Access Compliance Report

Public Rights-of-Way

(Pedestrian Signals)

Intersection ID: N/A	Main Street:	Cross Street: N/A	Location: N/A
ADA ID: FB4B390BC430	Signal Type: Two Push Buttons-Non APS	Overall Compliance: No	Severity Score: BTN 1:N/A BTN 2: N/A No BTN: N/A
Codes/Mitigation Info/Possible Solution		Field Measurements/Component Compliance

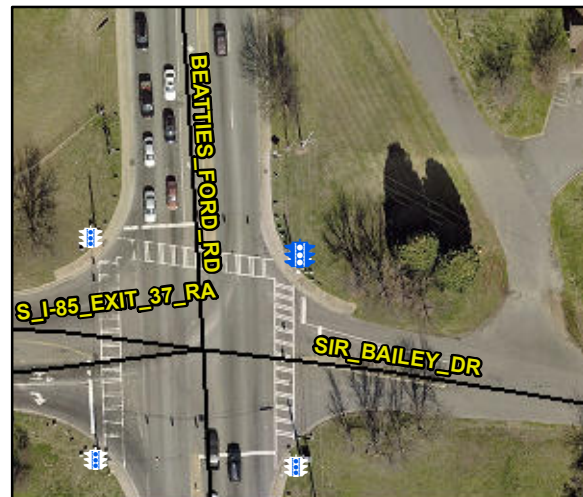
Compliance	Description	Data	Compliance	Description	Data
	Button Count	Button2	N/A	Distant to Additional Button (in)	N/A
	Additional Button Present?	No		Additional Button ID	N/A
N/A	Signal Buttons Required?	N/A	N/A	Additional Ped Posts Required	N/A
	How Many Ped Street Xings?	2		Located In An Island/Median?	No
N/A	B 1 Sign Present?	Yes	N/A	B 2 Sign Present?	Yes
Yes	B 1 Sign Purpose?	Yes	Yes	B 2 Sign Purpose?	Yes
Yes	B 1 Sign Lettering & Contrast?	Yes	Yes	B 2 Sign Lettering & Contrast?	Yes
Yes	B 1 Parallel To XWalk?	Yes	Yes	B 2 Parallel To XWalk?	Yes
Yes	B 1 PAR to Button?	Yes	Yes	B 2 PAR to Button?	Yes
Yes	B 1 PAR to XWalk?	Yes	Yes	B 2 PAR to XWalk?	Yes
Yes	B 1 Clear Floor Space?	Yes	Yes	B 2 Clear Floor Space?	Yes
N/A	B 1 FWD Approach?	No	N/A	B 2 FWD Approach?	No
N/A	B 1 FWD Approach Constrained?	No	N/A	B 2 FWD Approach Constrained?	No
N/A	B 1 FWD Approach Reach (in)	N/A	N/A	B 2 FWD Approach Reach (in)	N/A

N/A	B 1 FWD Approach Width (in)	N/A	N/A	B 2 FWD Approach Width (in)	N/A
N/A	B 1 FWD Approach Obstruction?	Yes	N/A	B 2 FWD Approach Obstruction?	Yes
N/A	B 1 FWD Approach Obstruction Dist (in)	5.0	N/A	B 2 FWD Approach ObstructionDist (in)	3.0
N/A	B 1 PARA Approach?	Yes	N/A	B 2 PARA Approach?	Yes
N/A	B 1 PARA Approach Constrained?	No	N/A	B 2 PARA Approach Constrained?	No
Yes	B 1 PARA Approach Reach (in)	10.0	No	B 2 PARA Approach Reach (in)	12.0
N/A	B 1 PARA Approach Width (in)	60.0	N/A	B 2 PARA Approach Width (in)	60.0
N/A	B 1 PARA Approach Obstruction?	Yes	N/A	B 2 PARA Approach Obstruction?	Yes
N/A	B 1 PARA Approach Obstruction Dist (in)	5.0	N/A	B 2 PARA Approach ObstructionDist (in)	3.0
No	B 1 Clear Floor Space Slope (%)	3.2	Yes	B 2 Clear Floor Space Slope (%)	3.5
No	B 1 Clear Floor Space XSlope (%)	12.1	No	B 2 Clear Floor Space XSlope (%)	8.1
N/A	B 1 PAR Slope (%)	1.4	N/A	B 2 PAR Slope (%)	3.9
Yes	B 1 Height (in)	36.0	Yes	B 2 Height (in)	36.0

Yes	B 1 Pressure (#)	1.0	Yes	B 2 Pressure (#)	1.0
Yes	B 1 Closed Fist Operation?	Yes	No	B 2 Closed Fist Operation?	No

Possible Solutions: Remove and Replace Clear Space. Replace Signal Push Button With APS Button.
